PACKAGE 3.4
 REACTOR COOLANT SYSTEM (RCS)
 PART E
 MARKUP OF NUREG-1431
 IMPROVED STANDARD TECHNICAL SPECIFICATIONS
 AND BASES

PRAIRIE ISLAND NUCLEAR GENERATING PLANT
 UNITS 1 AND 2

Improved Technical Specifications
 Conversion Submittal

3.4 REACTOR COOLANT SYSTEM (RCS)

Figure 3.4.16-1 (page 1 of 1)
Reactor Coolant DOSE EQUIVALENT I-131 Specific Activity
Limit Versus Percent of RATED THERMAL POWER

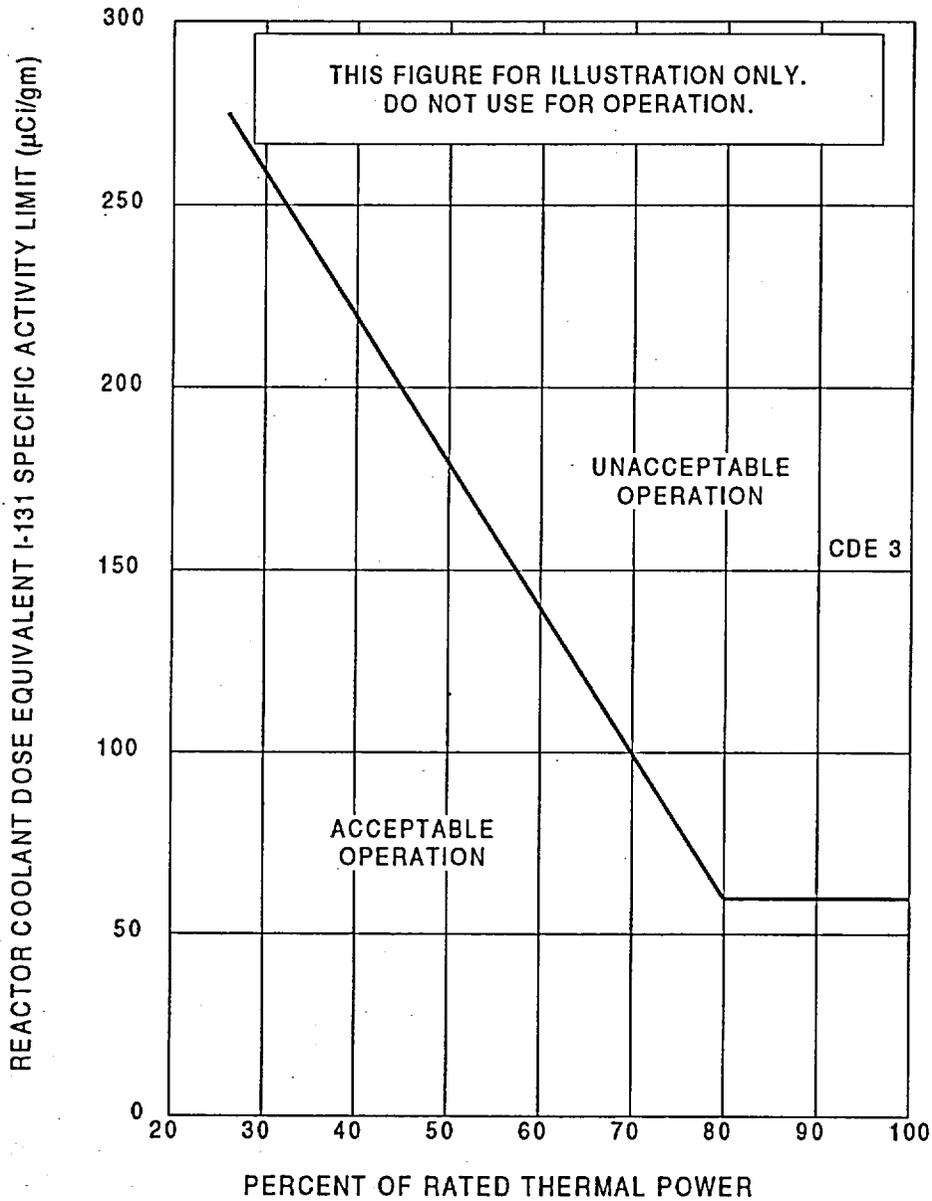
~~Replace with PI specific figure.~~
